Annex R

C-Port in Station Emulation Mode using the TKP Access Protocol

Details of Annex R Changes

Wilson Paper: 802.5-96/11-06

Figure R-1: C-Port in Station Emulation Mode Join (JS=State) Finite State Machine, TKP Access Protocol

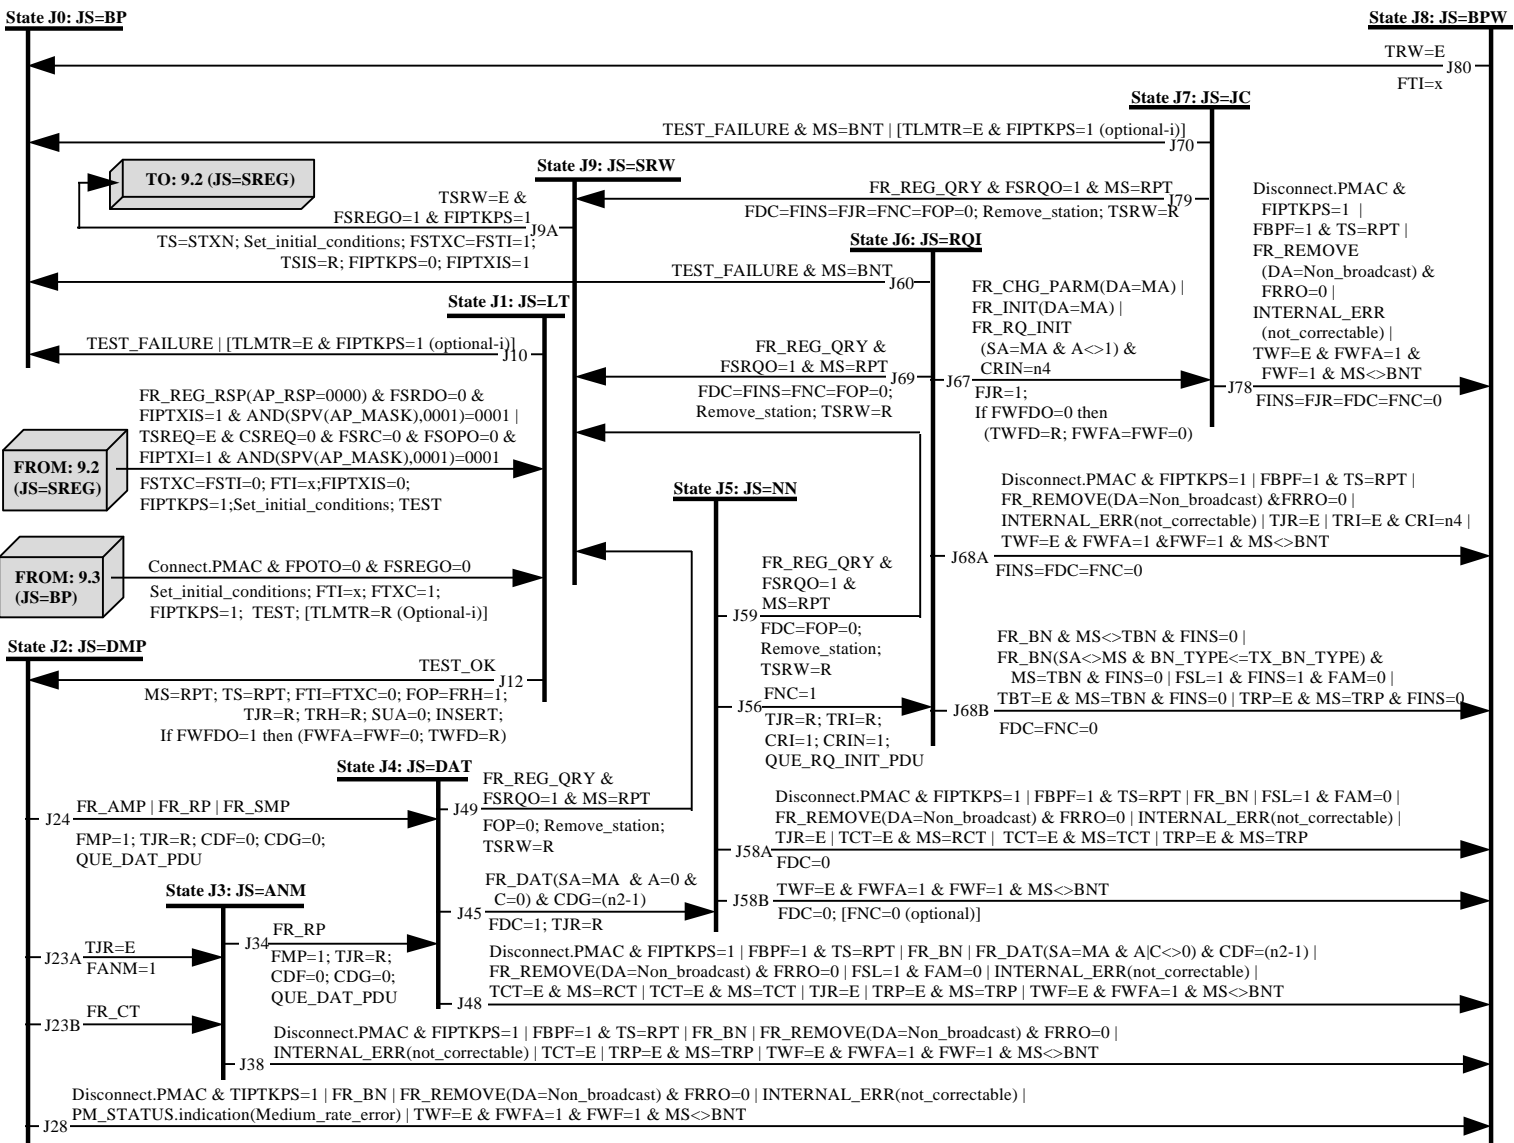
2. This paper updates the annex R released by Ken Wilson via the Proteon ftp site on October 23rd, 1996 as follows.
 - A) Figure R-1 page R-2 Join FSM has been changed as follows.

- 1) A new entry point has been added to agree with 9.2 (JS=SREG) as follows.
 - a) The new entry point event is as follows.
FR_REG_RSP(AP_MASK=0000) & FSRDO=0 &
FIPTXIS=1 & AND(SPV(AP_MASK),0001)=0001 |
TSREQ=E & CSREQ=0 & FSRC=0 & FSOPO=0 &
FIPTXIS=1 & AND(SPV(AP_MASK),0001)=0001

- b) The new entry point action as follows.
FSTXC=FSTI=0; FTI=x; FIPTXIS=0;
FIPTKPS=1; Set_initial_conditions; TEST
 - 2) Transition J12 event: The terms "FTI=0; FTXC=0;" are an incorrect notation and have been replaced by the single term: "FTI=FTXC=0;"

- 3) Transition J24 action: The term "CDF=CDG=0;" is an incorrect notation representation of counters and has been replaced by the two terms: "CDF=0; CDG=0;"

- 4) Transition J34 action: The term "CDF=CDG=0;" is an incorrect notation representation of counters and has been replaced by the two terms: "CDF=0; CDG=0;"

- 5) Transition J38 event: The term "FBPF=1 & MS=RPT" is incorrect and has been replaced by: "FBPF=1 & TS=RPT".
 - 6) The Transition J49, J59, J69 and J79 events: The terms "FSRW=1" are not in 9.5 and have been replaced by: "FR_REG_QRY & FSRQO= & MS=RPT".

- 7) Transition J48 event: The term "TCT=E & MS=RCT" is missing and has been added.
 - 8) Transition J58 has been changed because of a change in 802.5s as follows.

- a) Transition J58: The Transition has been renamed J58A and action term "TWF=E & FWFA=1 & FWF=1 & MS<>BNT" has been moved to the new Transition J58B (see "c)" below).

- b) Transition J58: The Transition has been renamed J58A and action term "FDC=0" has been added to agree with 9.5.
 - 9) A new Transition J58B has been added as follows.

- a) The J58B event is as follows.
TWF=E & FWFA=1 & FWF=1 & MS<>BNT
 - b) The J58B action is as follows.
FDC=0; [FNC=0 (optional)]
 - 10) Transition J69 action: The term "FDC=FINS=FJR=FNC=FOP=0" is incorrect and has been replaced by: "FDC=FINS=FNC=FOP=0".

- 11) Transition J68B event: The term "FSL=1 & FINS=0 & FAM=0" is missing and has been added.

Figure R-2: C-Port in Station Emulation Mode Transmit (TS=State) Finite State Machine, TKP Access Protocol

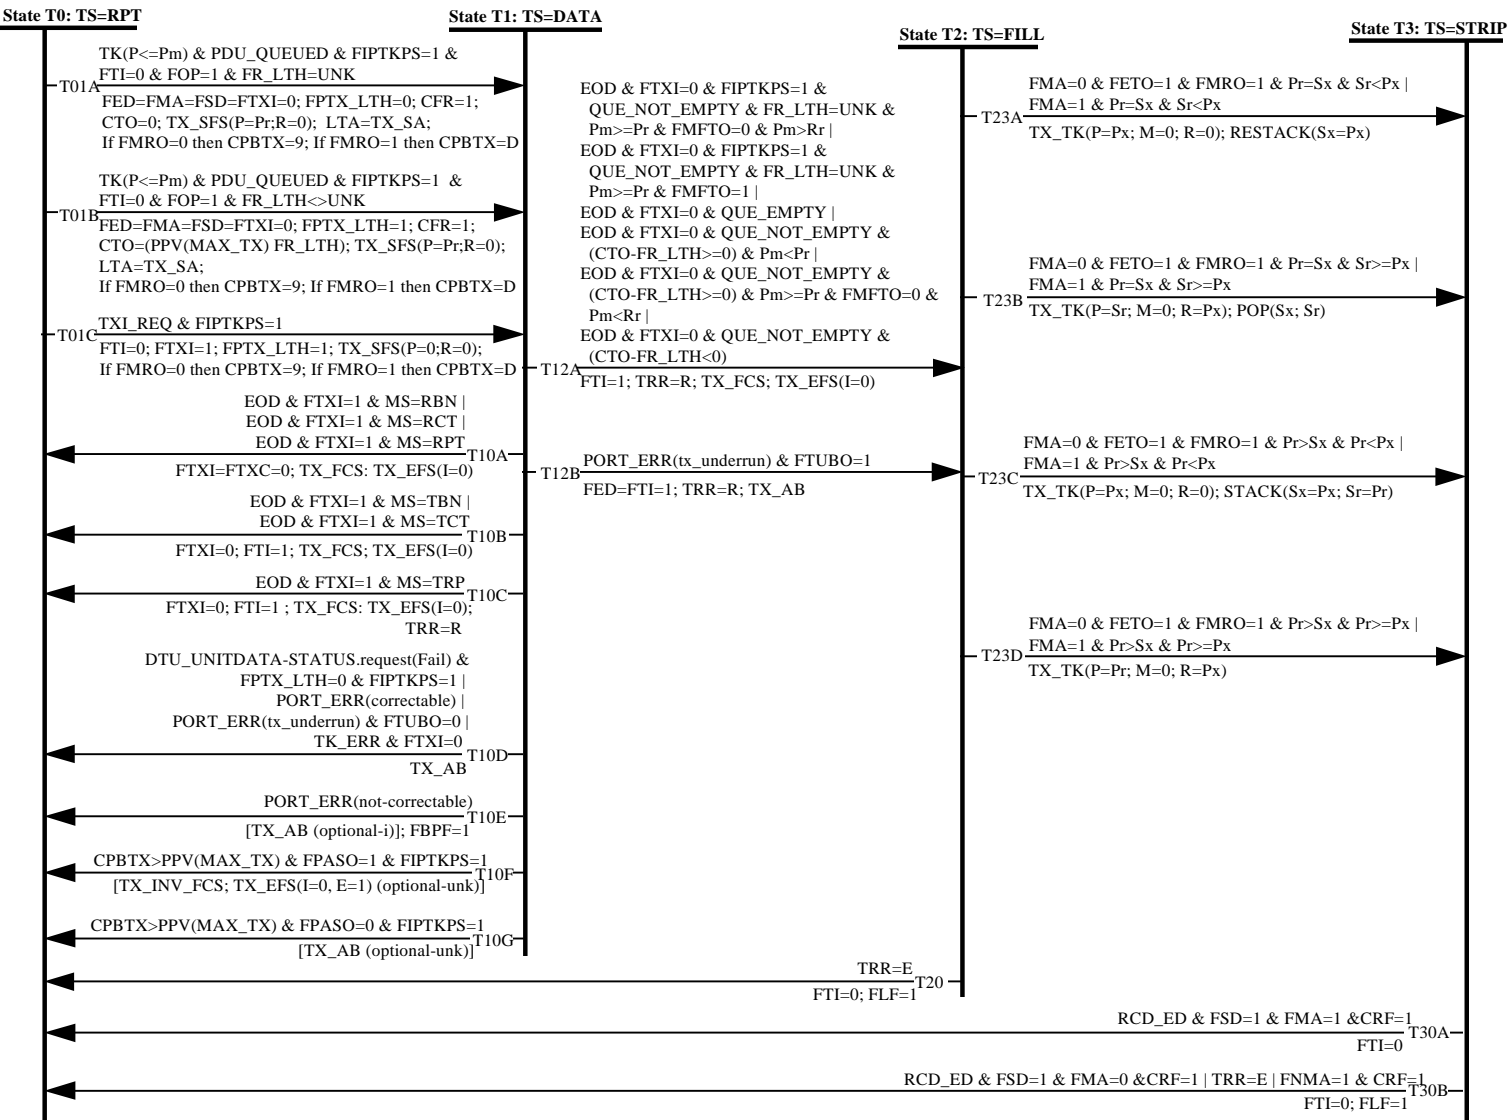
- B) Figure R-2 page R-3 Transmit FSM has been changed as follows.
- 1) Transition T10D action: The term "[TX_AB (optional)]" is incorrect and has been replaced by: "[TX_AB (optional-i)]".

- 2) Transition T12A action: The term "TRR=E" is incorrect and has been replaced by "TRR=R".
 - 3) Transition T12B action: The term "TRR=E" is incorrect and has been replaced by "TRR=R".

- 4) Transition T23D event: The term "Pr=Sx & Sr<Px" is incorrect and has been replaced with "Pr>Sx & Pr>=Px"
- C) Figure R-3 page R-4 Monitor FSM has been changed as follows.

Figure R-3: C-Port in Station Emulation Mode Monitor (MS=State) Finite State Machine, TXI Access Protocol

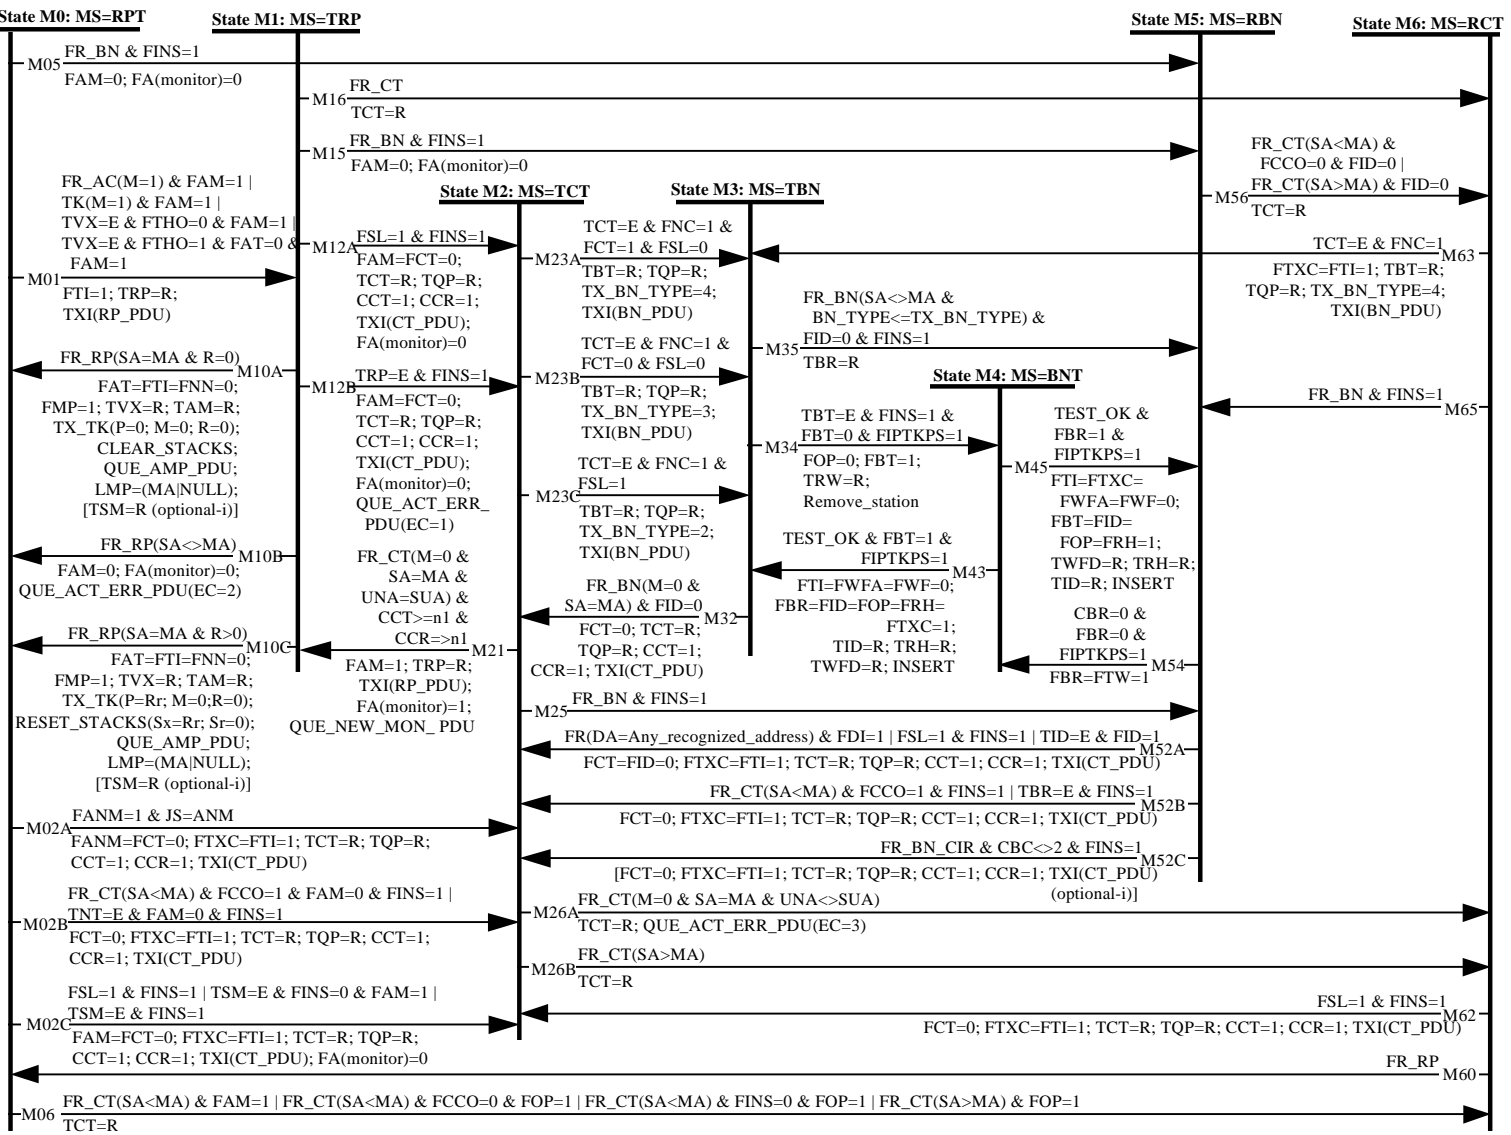
- 1) Transition M02A event: The term "FANM=1 & MS=RPT" is incorrect and has been replaced by: "FANM=1 & JS=ANM".
 - 2) Transition M06 event: The term "FR_CT(SA=MA) & FAM=1" is incorrect and has been replaced by "FR_CT(SA<MA) & FAM=1".

- 3) Transition M43 action: The term "FBR=FID=FOP=FRH=1" is incorrect and has been replaced by: "FBR=FID=FOP=FRH=FTXC=1".
 - 4) Transition M45 action: The term "TRH=R;" is missing and has been added.

- 5) Transition M54 was missing and has been added per 9.5 as follows.
 - a) The M54 event is as follows.
CBR=0 & FDR=0 & FIPTKPS=1
 - b) The M54 action is as follows.
FBR=FTW=1

- 6) Transition M65 event: The term "FNC=1" is incorrect and has been replaced by "FINS=1".
